Access Compliance Report

Public Rights-of-Way

(Curb Ramps)

Intersection ID: 4086	Main Street: CLAYBROOKE_DR	Cross Street: SANRIDGE_WIND_LN	Location: SE
ADA ID: 8D6A701449CA	Ramp Type: Perp	Initial Pass/Fail: Fail	Overall Compliance: No
Severity Score: 46.25			
Codes/Mitigation Info/Possible Solution		Field Measurements/Component Compliance

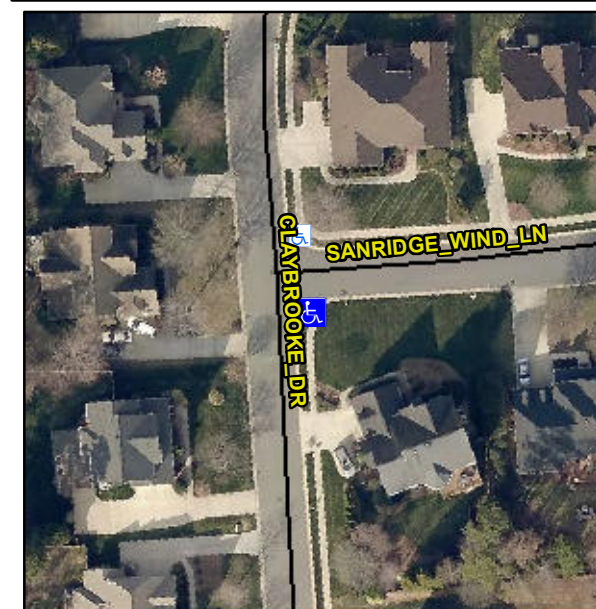
Not Found, R304.5.1, R304.2.2, R304.5.3

Compliance	Description	Data	Compliance	Description	Data
N/A	Ramp Length (in)	96.0	No	Ramp Slope (%)	9.1
No	Ramp Width (in)	43.5	No	Ramp XSlope (%)	12.4
N/A	Flare Type LT	N/A	N/A	Flare Type RT	N/A
N/A	Flare Slope LT (%)	N/A	N/A	Flare Slope RT (%)	N/A
N/A	Flare Traversable LT?	N/A	N/A	Flare Traversable RT?	N/A
N/A	Landing Length (in)	N/A	N/A	DWS Provided?	N/A
N/A	Landing Width (in)	N/A	N/A	DWS Contrast?	N/A
N/A	Landing Slope (%)	N/A	N/A	DWS Length (in)	N/A
N/A	Landing X Slope (%)	N/A	N/A	DWS Full Width?	N/A
N/A	Landing Curb? (Y/N)	N/A	N/A	DWS Offset (in)	N/A
N/A	Shared Landing?	N/A			
N/A	Gutter Ponding?	N/A	N/A	Gutter Slope (%)	N/A
N/A	Gutter Lip Ht (in)	1.0	N/A	Gutter X Slope (%)	N/A
N/A	Painted X Walk1?	No	N/A	Painted X Walk2?	N/A
	X Walk 1 Direction	To N		X Walk 2 Direction	N/A
N/A	X Walk 1 Width (in)	N/A	N/A	X Walk 2 Width (in)	N/A
	X Walk 1 Slope (%)	0.3		X Walk 2 Slope (%)	N/A
	X Walk 1 X Slope (%)	5.5		X Walk 2 X Slope (%)	N/A

Remove & Replace Entire Ramp.
